**PLANNED UNIT DEVELOPMENT
& SUBDIVISION STAFF REPORT****Date: May 7, 2009****DEVELOPMENT NAME**

Josephine Allen Subdivision

Planned Unit Development Approval to allow multiple buildings on a single building site in a Multi-Family Residential District, and Subdivision approval to create 3 lots.

SITE PLAN

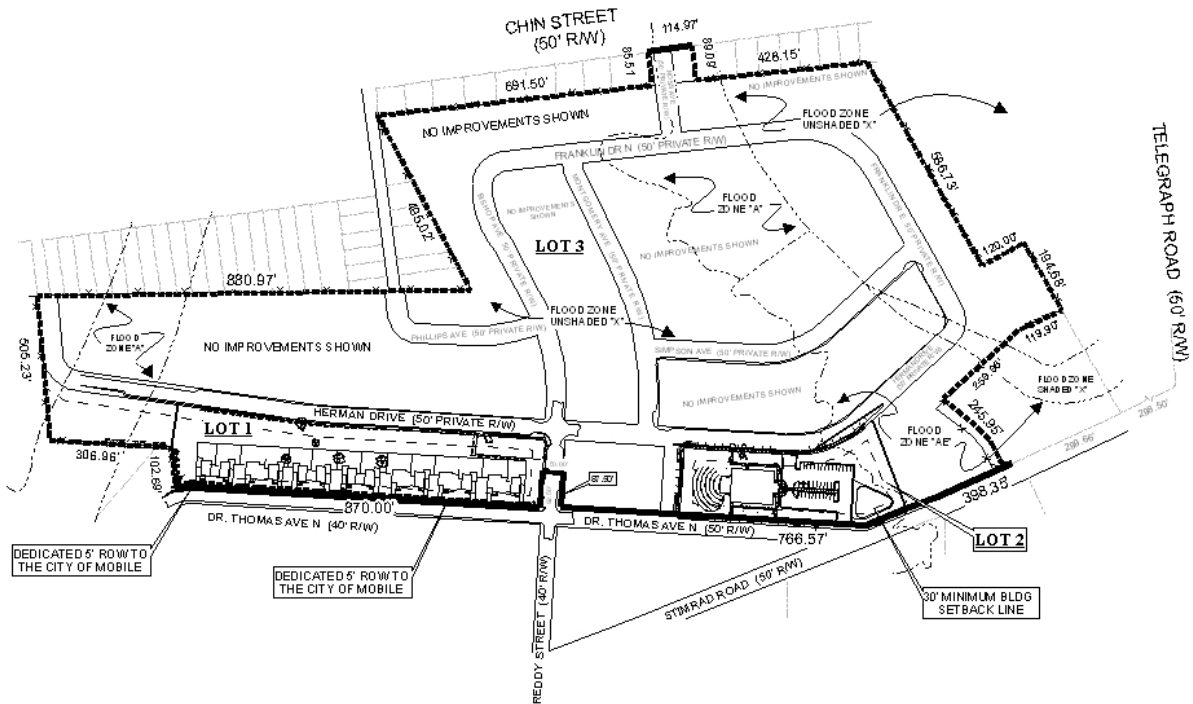
The PUD site plan was revised to show existing trees, as requested, and a new dumpster, as requested. Urban Forestry has revised their comments, found on the second page of this report, to convey preservation status to several existing trees, including a 36-inch live oak tree that is proposed for removal due to a driveway: relocation of the driveway or a shifting of the proposed homes may be preferred by Urban Forestry.

Regarding the proposed residential development on Lot 1, the applicant has included a note on the site plan stating that the site will comply with the tree and landscape requirements of the Zoning Ordinance, as well as the PUD common area requirements: actual compliance is not depicted. The design professional making the application for the overall PUD is not the same design professional responsible for the detail design of the development on Lot 1, thus they did not believe that they could assume the responsibility of depicting site compliance. Therefore, drawings depicting full compliance will be required for Lot 1 at the time of submittal for land disturbance or building permits for Lot 1. Furthermore, if buildings or driveways must be shifted to accommodate tree preservation requirements, a revised PUD site plan must be submitted prior to applications for land disturbance (if the changes are significant, a new application may be required).

Regarding the proposed cultural arts center on Lot 2, the site plan depicts a dumpster served by a new curb-cut from Herman Drive, a private street. Servicing of a dumpster at the proposed location will require a truck to block the private street and maneuver in the private street while emptying and replacing the dumpster. It is advised that the dumpster location be changed so that it can be serviced from within the parking lot of the proposed development, however, it should be noted that Engineering now requires that all dumpster pads drain to sanitary sewer. The landscape calculations for the development on Lot 2 are provided, but proposed tree locations are not indicated: a site plan depicting full compliance, including tree location, will be required with land disturbance or building permit applications.

It appears that the corner radius for Lot 2, requested by the Engineering Department, was not depicted on the revised drawings.

- 5) Revision of the site plan to relocate the proposed screened dumpster so that it is serviced from within the parking area of the cultural arts center proposed on Lot 2;
- 6) Removal of the “future development” label on Lot 3;
- 7) Submission of a revised PUD site plan prior to any request for land disturbance or building permits, and prior to the signing of the final plat;
- 8) Development of the site to be undertaken in compliance with all local, state and Federal regulations regarding endangered, threatened or otherwise protected species;
- 9) Development to comply with all applicable federal, state and local regulations relating to floodplain development; and
- 10) Full compliance with all other municipal codes and ordinances.

SUBDIVISION DETAIL

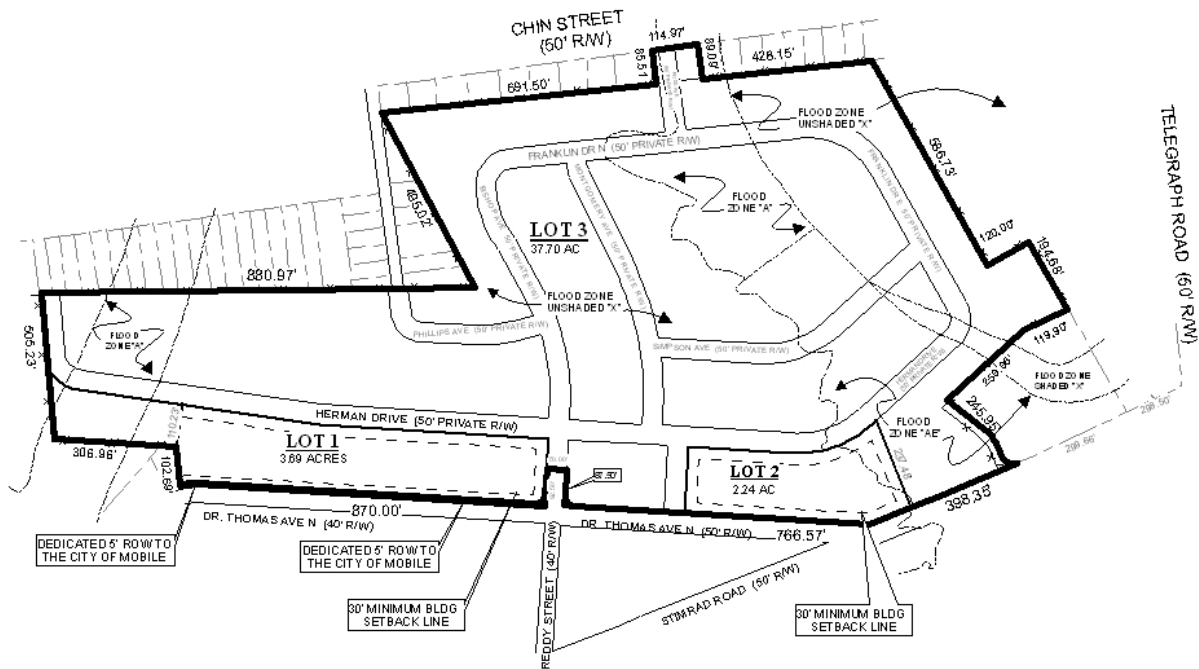
A revised PUD site plan and Subdivision plat were submitted by the applicant. The Subdivision plat was revised to reflect the required dedication along Dr. Thomas Avenue North, but also to change the western boundary of proposed Lot 1, making it approximately 1 acre smaller than originally submitted (the size of Lot 3 was increased). The plat also depicts a corrected boundary for proposed Lot 2 (the boundary on the plat did not match that on the PUD site plan). Lot 3 is labeled as “future development” when, in fact, it is already developed and in use.

- 3) Placement of a note on the final plat stating that curb-cuts for Lots 1, 2 and 3 are limited to an approved Planned Unit Development, with the size, design and location of any new curb-cuts to be approved by Traffic Engineering and to conform to AASHTO standards;
- 4) Removal of the "future development" label on Lot 3;
- 5) Submittal of a revised PUD site plan;
- 6) Development of the site to be undertaken in compliance with all local, state and Federal regulations regarding endangered, threatened or otherwise protected species;
- 7) Development to comply with all applicable federal, state and local regulations relating to floodplain development; and
- 8) Completion of the Subdivision process prior to any request for land disturbance or building permits.
